Access Compliance Report Public Rights-of-Way (Pedestrian Signals)

Main Street: CARBON_CANYON_RD Cross Street: VALENCIA_AVE Location: SE

ADA ID: SGAT210920110410 Signal Type: One Push Button-APS Overall Compliance: No Severity Scores: BTN 1: 0 BTN 2: N/A No BTN: N/A

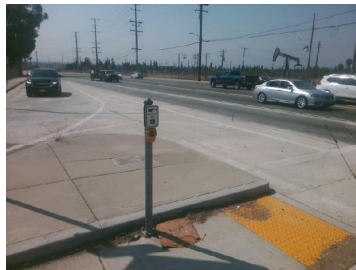
Possible Solutions: Replace Signal Push Button With APS Button. Remove & Relocate Sign.
